Legislative Requirements (i.e. District Plan / Standards / Design Guides)

The drainage and water supply infrastructure design requirements are covered by Wellington Water Ltd's Regional Standards for Water Services - May 2019 (RSWS), and the construction requirements are covered by Wellington Water Ltd's Regional Specification for Water Services May 2019.

Figure 4 Existing wastewater network on the Site

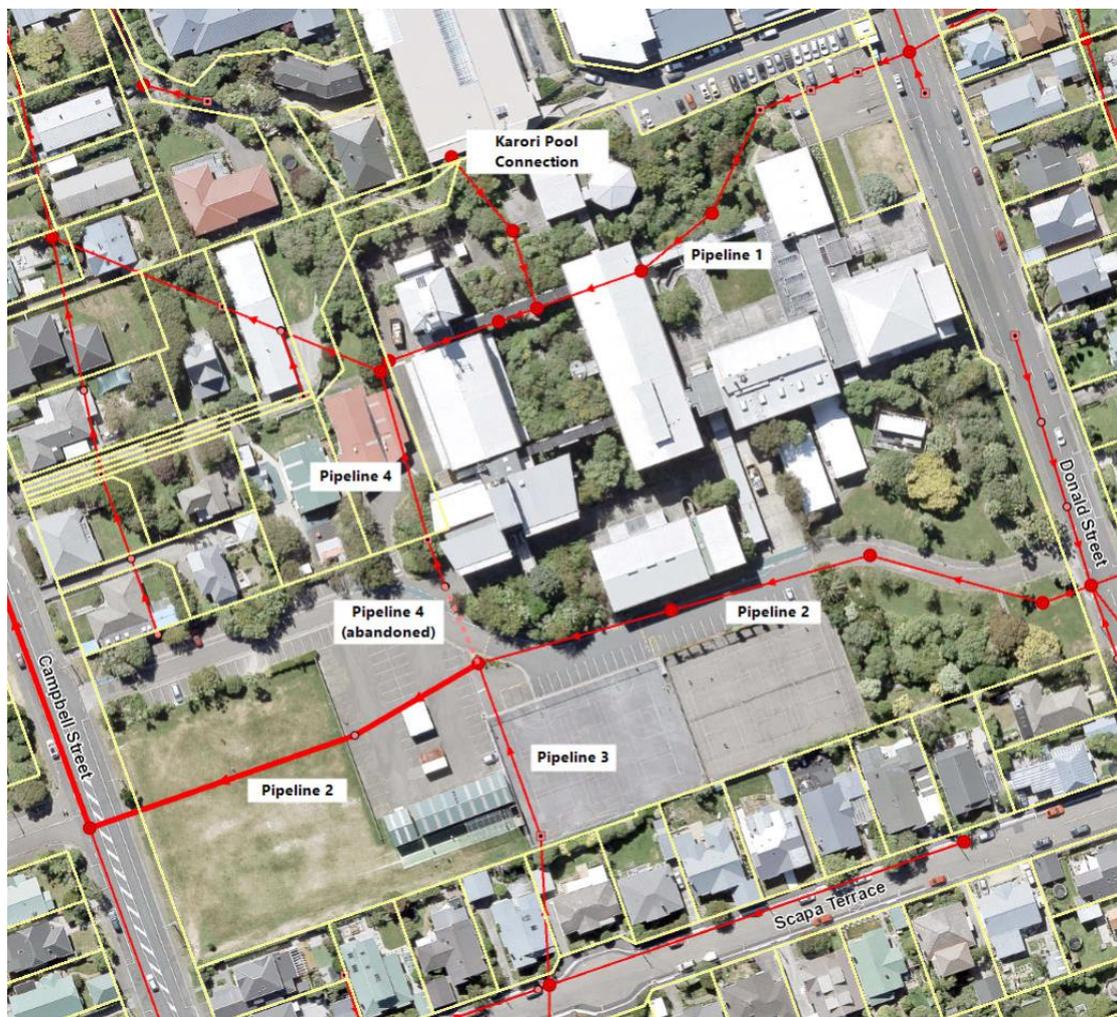
The WCC public stormwater network runs through the Site, see figure 4 below.

Ryman has collected historic information on occupancy rates and wastewater loads for this type of village. Domestic sewer loads are on average 160 litres/resident/day,

with a peaking factor of 3, based on information that has been collected by Ryman on sewer loads for its operational comprehensive care retirement villages. This includes allowance for all core functions such as kitchens, common rooms and staff usage.

These figures are less than the domestic flowrates specified in the RSWS and in response to a further information request Ryman supplied the used to support these design figures. This supporting information has been reviewed and accepted by Wellington Water's Chief Advisor for Wastewater.

Wellington Water provided Woods flow data from their Karori WWTP 2017 (current) model for the 1-year Long Time Series (LTS) design event. Based on Ryman's flowrates the peak flowrate from the proposed development is 2.0 l/s which is less than the current peak flowrate from the Site allowed for in the Wellington Water model.

While Wellington Water's Karori WWTP model indicates that the local network has 1 l/s spare capacity it also shows that the trunk network that are already over their design capacity during a 1-year LTS design event with overflows of over 50m³ and 500m³ occurring into the Karori Stream at engineered overflows. Hence the wastewater generated by the development of this Site will require careful consideration at Engineering Approval stage as on site wastewater detention maybe required.

Figure 5 Proposed public wastewater network on Site.

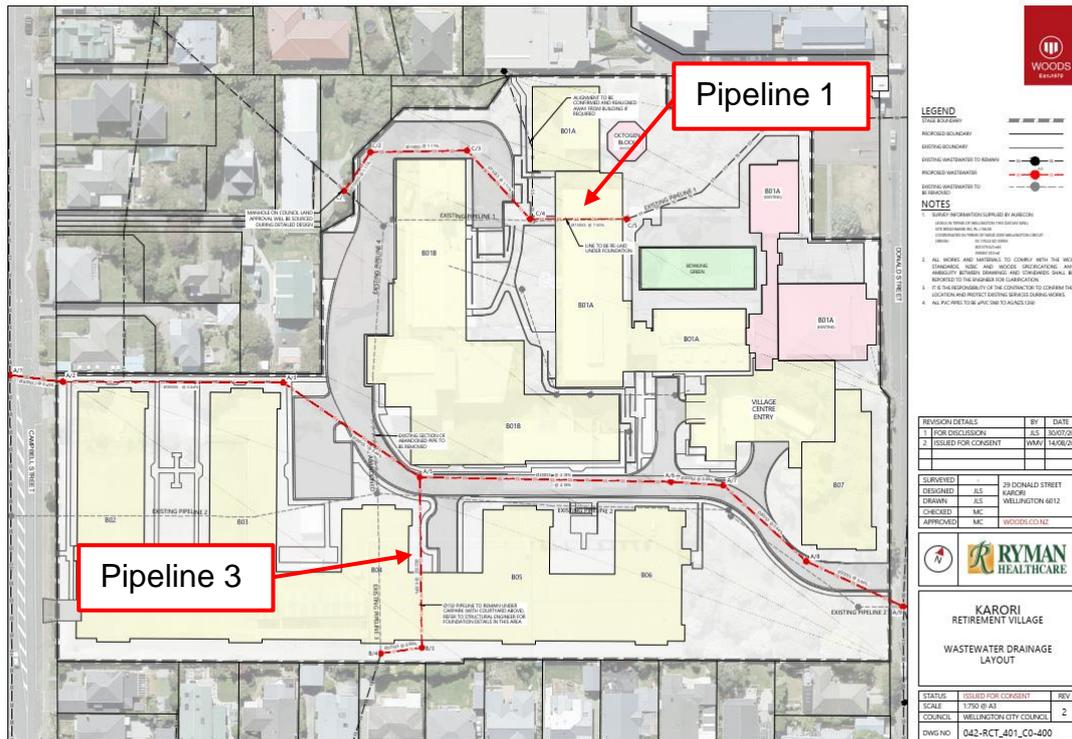
The Site has existing gravity sewer lines that convey wastewater from upstream catchments through the Site. These lines also convey the wastewater from the existing buildings on the Site. The existing lines will need to be realigned through the Site to avoid buildings and underground services where possible, see Figure 5 below.

There is no feasible option to divert pipeline 1 around Building B01A, therefore the line will be lowered to avoid the foundations of this building. This is an improvement over the existing scenario where the line passes under two existing buildings.

Pipeline 3 will be realigned to avoid the new Building B04, this will involve passing below a carpark with a courtyard above. This is the best practical solution to avoid the building.

The realigned gravity pipelines have the capacity to convey PWWF from the upstream catchment as well as the Proposed Village to meet the requirements of Wellington Water.

Advice notes shall cover the requirement for the detailed design any proposed pipes under buildings requiring Wellington Water acceptance.
